Date September 13, 2018  
To Town of Cumberland Planning Board  
From Carla Nixon, Town Planner  
Subject **Major Site Review: Belted Cow Office Building**

## **PEER REVIEW ENGINEER'S COMMENTS: Jeff Read, P.E. Sevee and Maher Engingeers.**

Subject: Peer Review of Belted Cow Site Plan Application  
Lot 5, Cumberland Foreside Village  
Cumberland, Maine

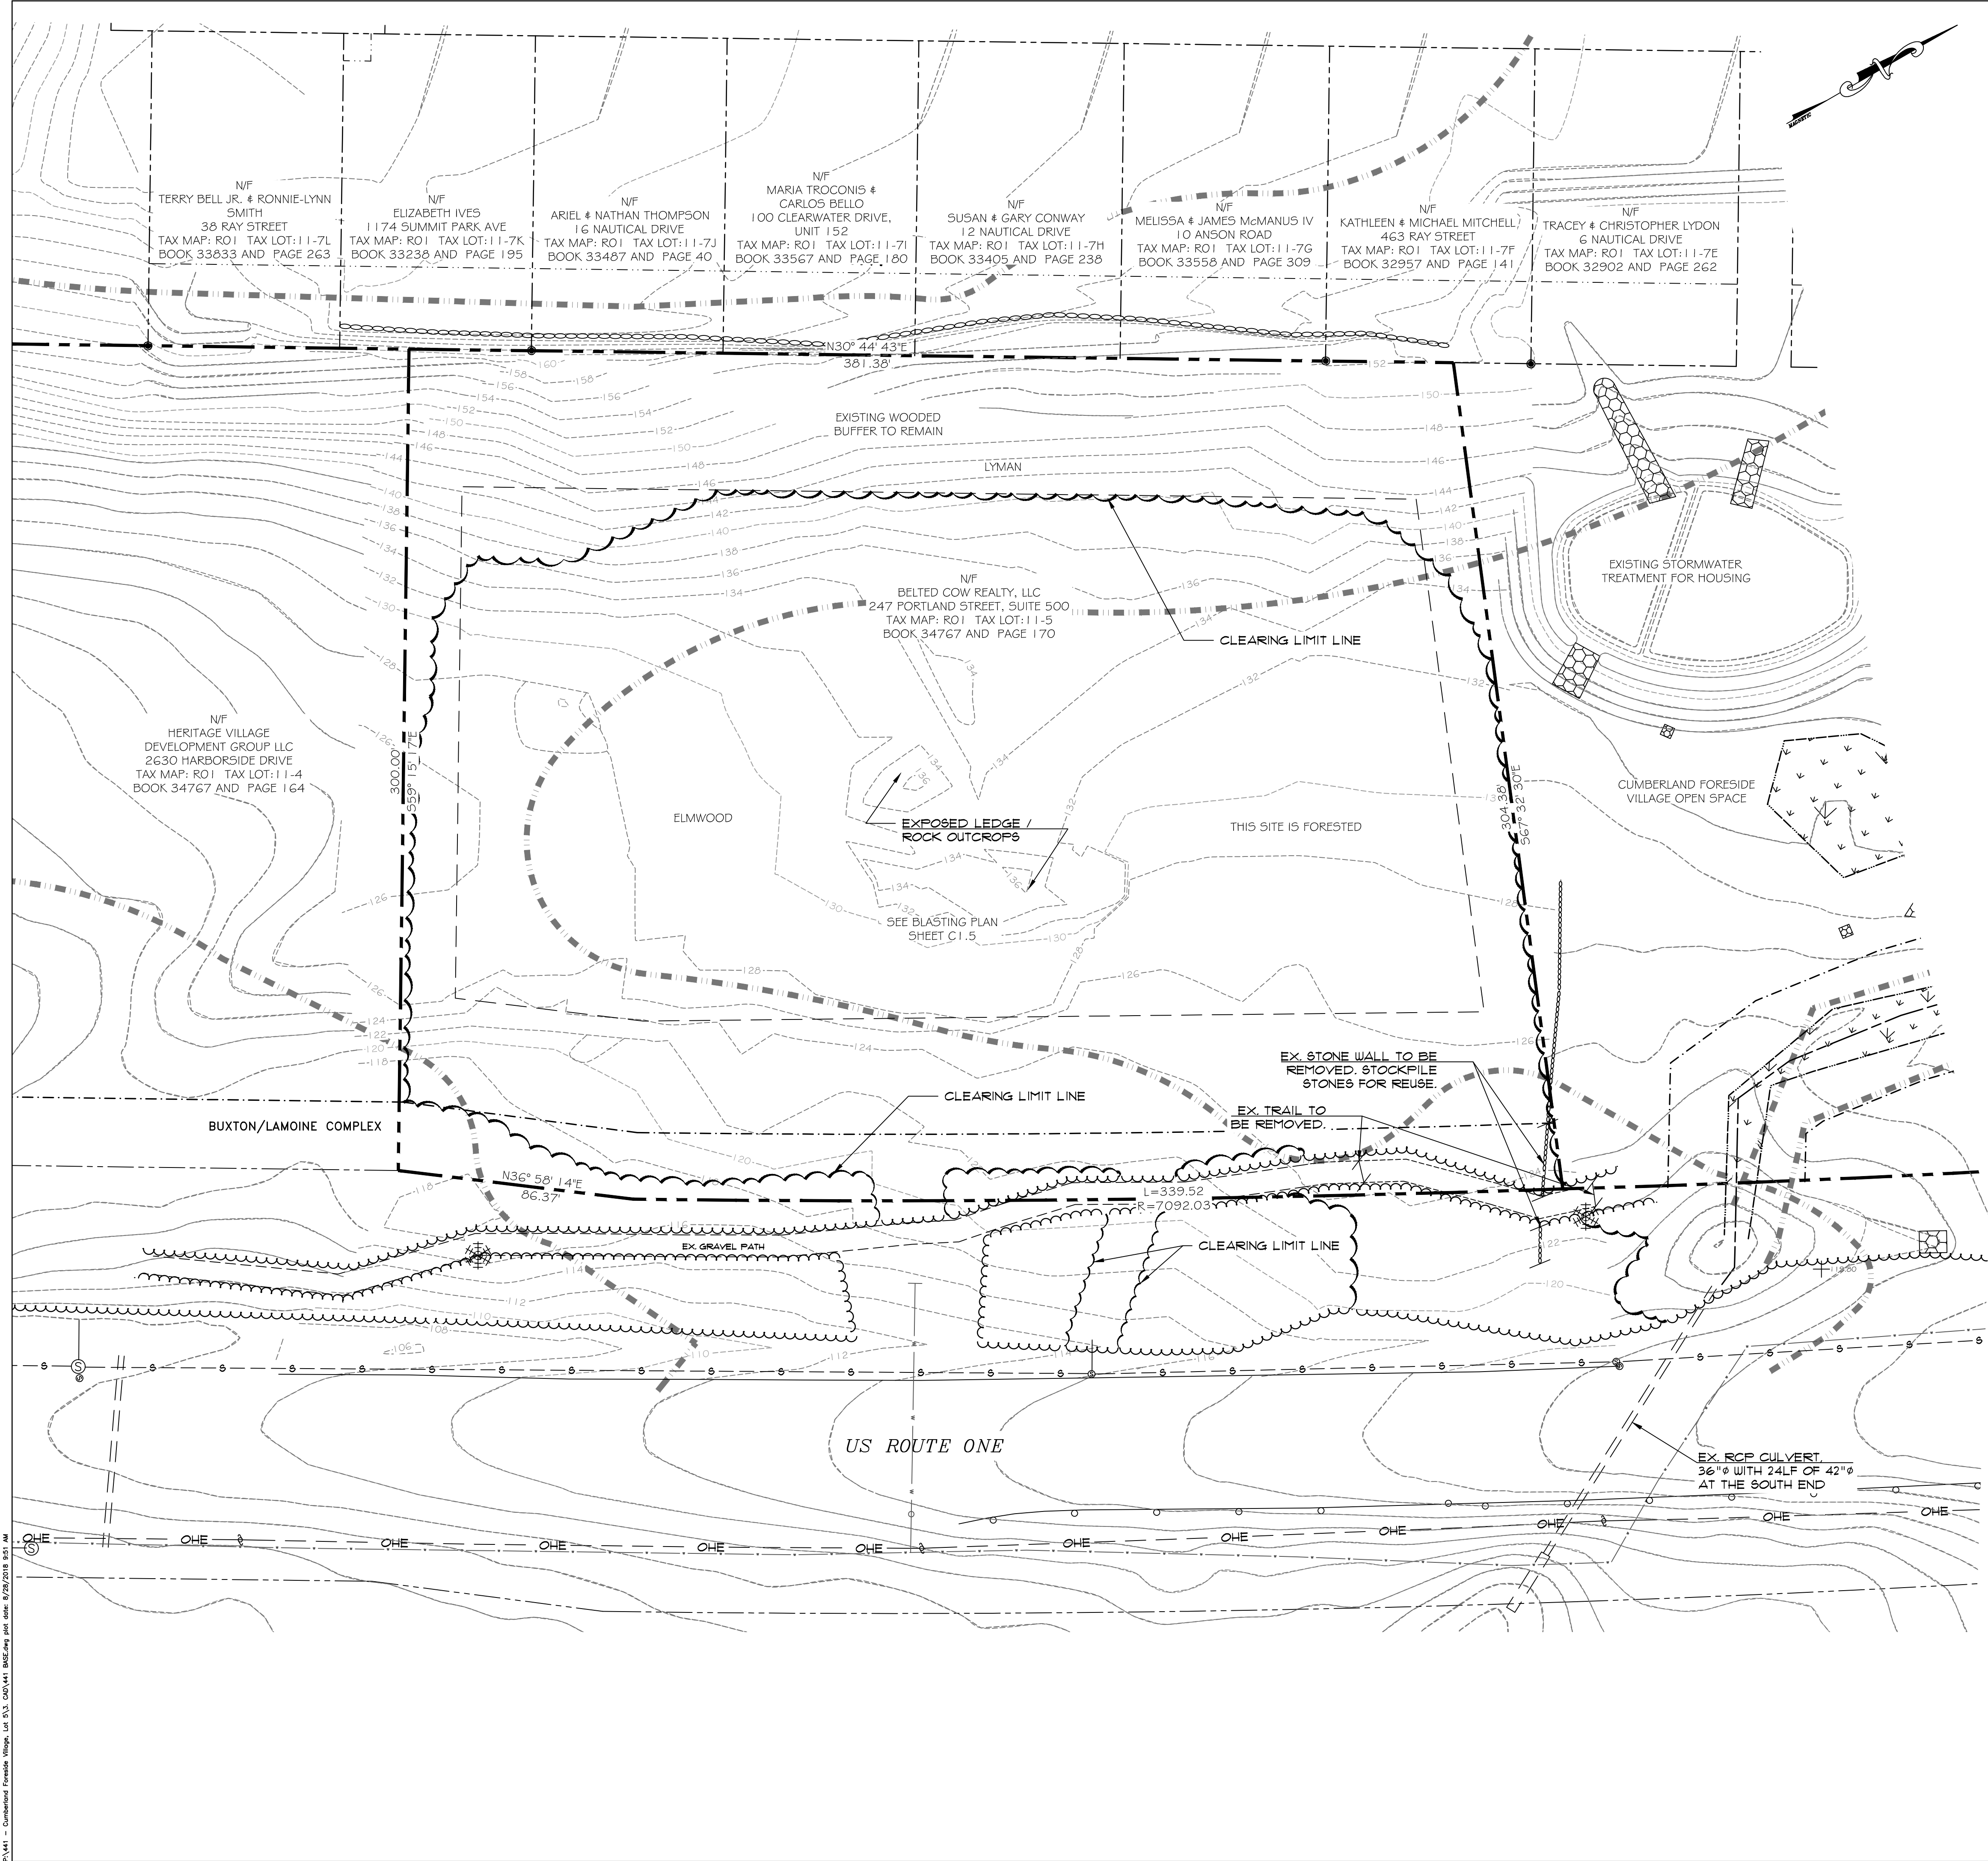
10. Plan sheet C1.1 outlines wetlands mapping is taken from a plan dated March 20, 2007. Industry standard generally requires updated mapping for surveys older than 5 years. SME recommends the applicant provide updated wetland information prior to final approval.
11. SME recommends the Applicant request waivers from the requirement to provide a high intensity soils survey, a hydro geologic evaluation, a market study, location of proposed recreation areas, and location and type of outdoor furniture and features.

10. Plan sheet C1.1 outlines wetlands mapping is taken from a plan dated March 20, 2007. Industry standard generally requires updated mapping for surveys older than 5 years. SME recommends the applicant provide updated wetland information prior to final approval.

Sheet No.:  
**D2.0**

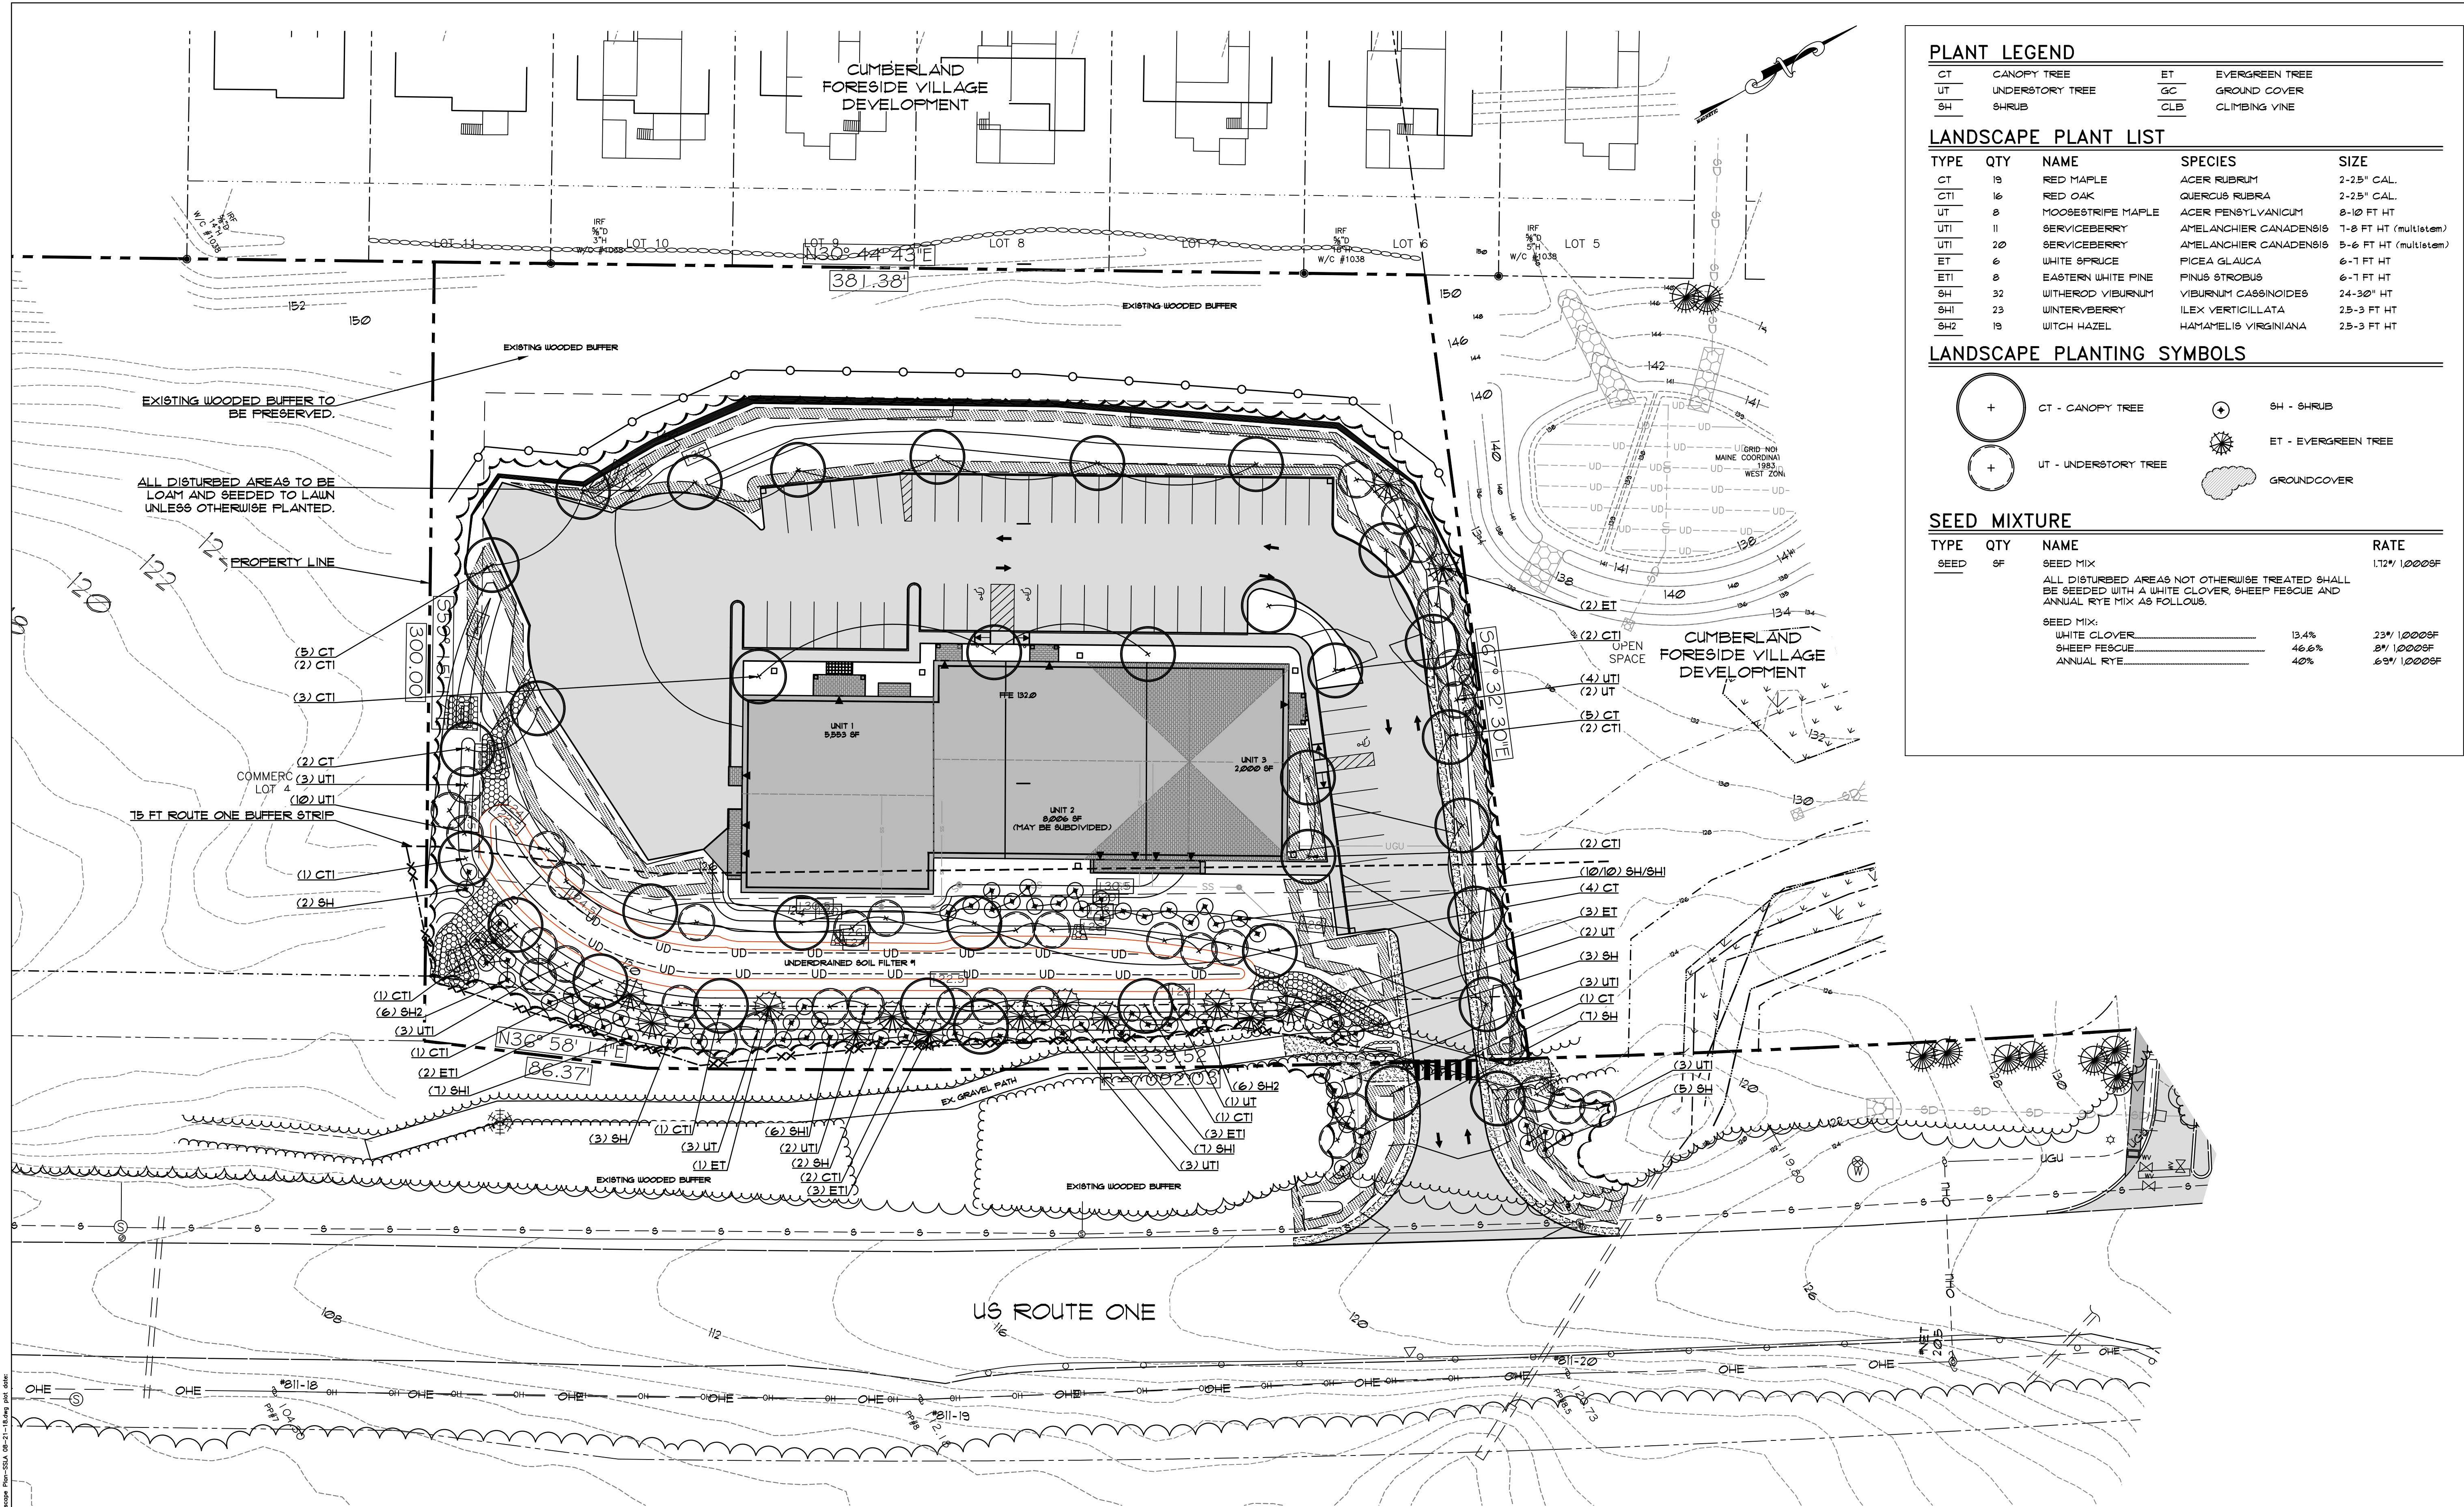
5. The Stormwater Management Report outlined an increase in impervious area beyond what was previously approved. Please verify an amendment is not required for the existing MEDEP SLODA permit for the site.
6. The Pre-Development treatment area is 0.67 acres larger than the Post-Development treatment area. This is outlined on plan sheets D1.0 and D2.0 and the Area Listings included in the Stormwater Management Report. Please update the runoff calculations to provide an accurate representation of peak flow increases on the property.

6. The Pre-Development treatment area is 0.67 acres larger than the Post-Development treatment area. This is outlined on plan sheets D1.0 and D2.0 and the Area Listings included in the Stormwater Management Report. Please update the runoff calculations to provide an accurate representation of peak flow increases on the property.
